#### **Comments on Subchannelization**

IEEE C802.16a-02/101

# Subchannelization related Comments

# Proposed Text change

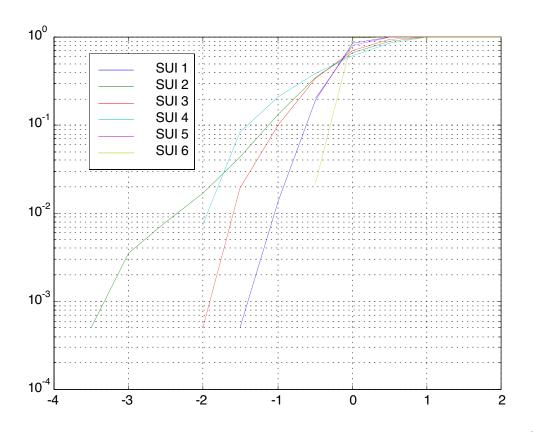
- A SS first performs network entry in the OFDM mode
- Only if it fails: It may try in Subch mode.
- Consequence: **Any** SS can enter Subch capable BSs.
- No interoperability problem.

• In pg 162...

"The initial ranging interval can be allocated to SSs which use subchannelization. In this case the BS allocates an UL interval, to be used with sub-channelization. Using the procedure of 8.4.4.3.5 and an UIUC code of 1 in the OFDM UL MAP Information Element will be possible to specify on which sub-channel will be sent the initial ranging burst.

An SS will first attempt to perform the initial ranging in full OFDM mode. If the network entry process failed, the SS may try to use the network entry sub-channelization mode."

• In pg 170

Change footnote under table 116av to "... UIUC 1 through 13"
